Subject: **Holder 245 Series body marking change**

This is a 60-day PCN

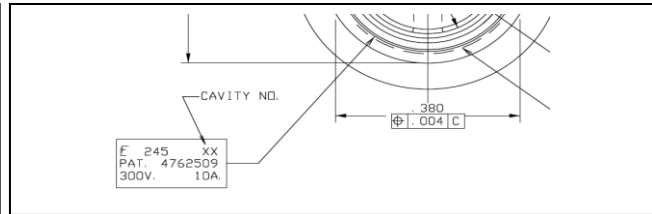
Littelfuse Product Management would like to inform you that the legend of "250 V" to "300 V" from the holder's plastic body of the 245 Series will be changed in order to be compliant with our specifications.

There are no changes in form, fit, function, or materials to our part. Current ratings for all other approving agencies remain unchanged:
